## MSB D4-087

Inspection of battery relay.

### Inspection of Battery Relay

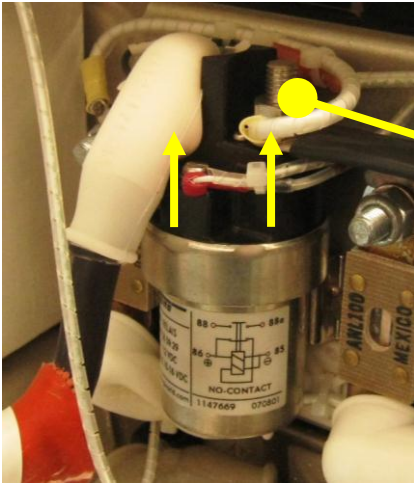
1	<p>Remove engine cowlings (refer to AMM Section 71-11).</p> <p><b>WARNING MAKE SURE THAT THE ENGINE IS SAFE BEFORE YOU WORK NEAR THE PROPELLER.</b></p> <ul style="list-style-type: none"> <li>- SET THE ELECTRIC MASTER KEY SWITCH TO "OFF".</li> <li>- SET THE ENGINE MASTER SWITCH TO "OFF".</li> <li>- SET THE POWER LEVER TO "IDLE".</li> </ul>
2	<p>Disconnect the Battery for Maintenance i.a.w. AMM Section 24-34.</p> <p><b>CAUTION DISCONNECT THE BATTERY BEFORE DOING MAINTENANCE ON THE ELECTRICAL SYSTEM. MAKE SURE TO DISCONNECT THE NEGATIVE LEAD FIRST.</b></p>
3	<p>Remove the nuts and washers from the coolant radiator mounting points and raise the coolant radiator, to ease access to the relay box,.</p> <p>Note            You do not have to remove the radiator.</p>
4	<p>Remove the cover from the relay box.</p>
5	<p>Make sure that the nuts on the battery relay are tightened correctly (torque 13 Nm). Apply Torque Seal.</p> <p>Note            The protection cap must be removed for inspection on the RH side nut.</p> <div style="text-align: center;">  <p style="text-align: right;">Torque Seal</p> </div> <p style="text-align: center;">Figure 1: Battery Relay</p>
